Operational Readiness Clearance (Non-beam operation)
SeaQuest E906 New Tracking Station 1
9 Oct 2015

AUTHORIZATION TO PROCEED WITH THE UNATTENDED OPERATION OF
FLAMMABLE GAS FLOW AND HV IN NEW STATION 1 OF SEAQUEST

SEAQUEST FLAMMABLE GAS

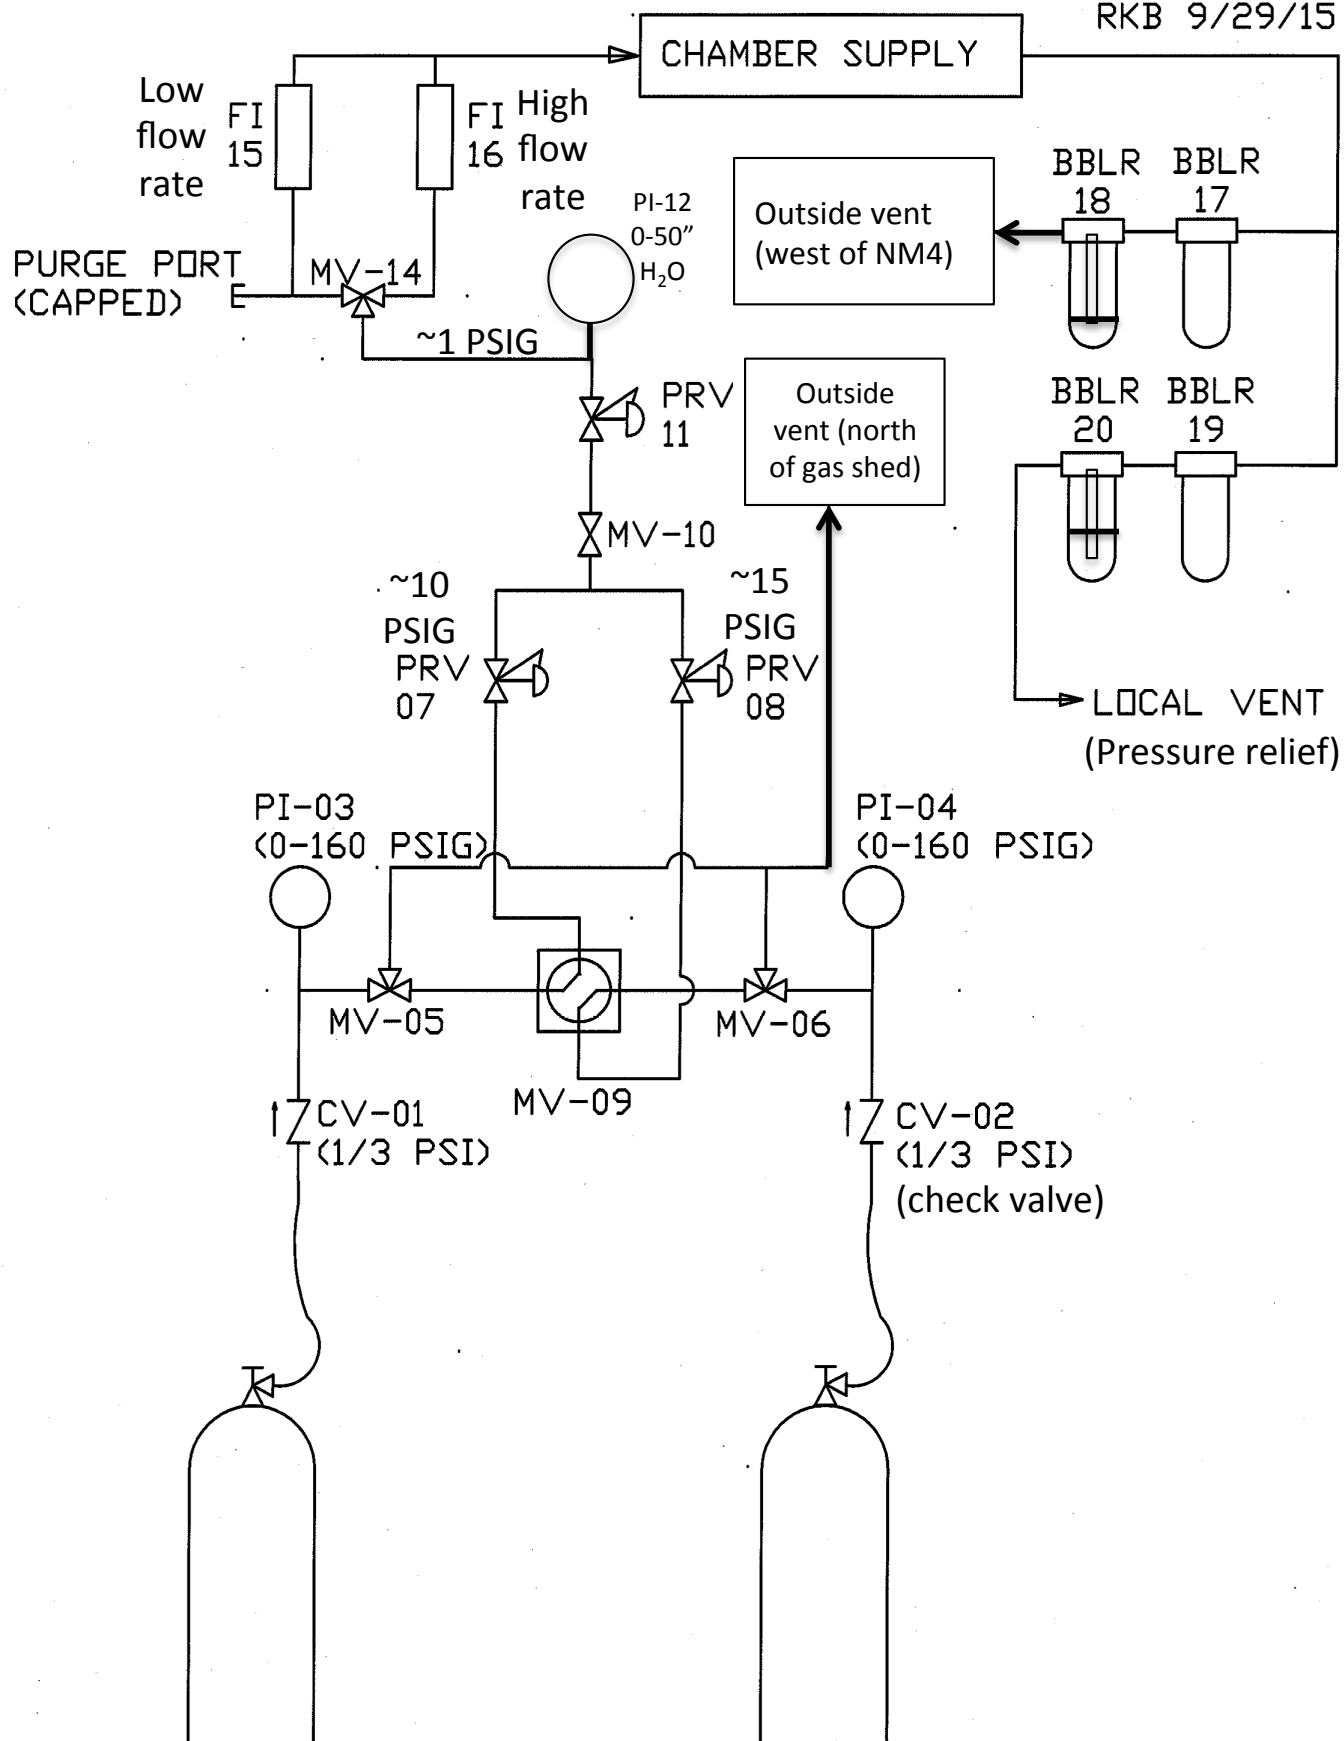
The gas shed is appropriately vented and powered for flammable gas; the piping system is as described in the documentation; signage has been applied to lines, flow meters, etc., indicating flammable gas. In lieu of a fixed orifice there is an adjustable needle valve to control overall output from the gas bottles. This is located in an enclosed ventilated box, so the chance of anything dislodging it is remote. Coupled with the total inventory of two premix bottles on line at a time (see documentation provided by David), this is sufficient.

The experimental hall piping and chamber have appropriate signage and the piping has sufficient protection from damage. The pieces of piping going to and from the chamber are Polyflo, chosen to minimize potential damage (and therefore leakage) when disconnection and reconnection is required. Polyflo is appropriate for the pressures involved. Of note concerning the Class 0 calculations is that even if the total inventories of the two possible online bottles plus the chamber were to empty into the hall it would still be in the same Class. There is no other flammable gas in the hall to add to the inventory.

To do at the next opportunity (but not necessary for approval to flow gas). Maddie: could you please arrange to have a flammable gas sign put on the exit to the copper vent pipe where it terminates outside the building on the west side? It is behind a locked rad (?) fence so we could not access it.

Here (attached) is a revised version of the gas piping schematic that makes it clear that there are two outside vents. Gas flow through the chamber vents through a copper pipe outside of NM4 on the west side of the building. When we change gas bottles, we will vent a small amount of gas through a PVC pipe in the gas shed in order to make sure that air doesn't get into the chamber.
